Planning Commission
App. No. 090-2014-TA

Zoning Text Amendment Guilford Township

Meeting: December 2, 2014
Applicant: Guilford Township Zoning Commission (GTZC)
Hearing: December 11, 2014 (Zoning Commission)
Amendment: Section 6.5 Driveways (Residential)
Reviewer: Rob Henwood

APPENDIX 11: DRIVEWAY CONSTRUCTION REQUIREMENTS

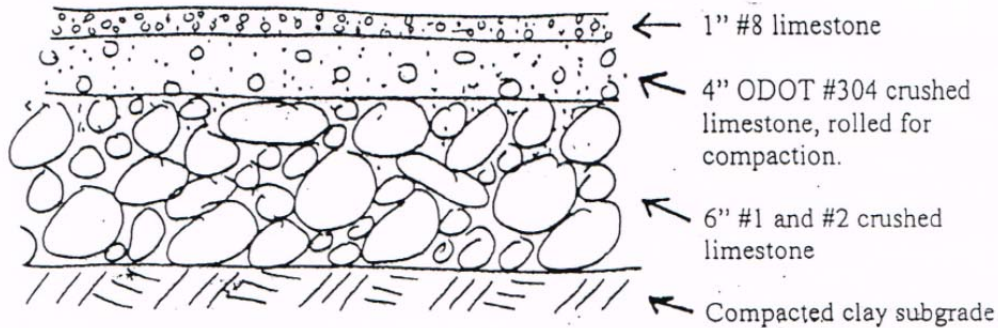
§ 6.5.2 above indicates that the “driving section” of a proposed driveway be a minimum of ten feet wide whereas the figure for Appendix 11 above indicates an “aggregate section” is to be 12 feet wide. The appendix should be consistent with the proposed text.
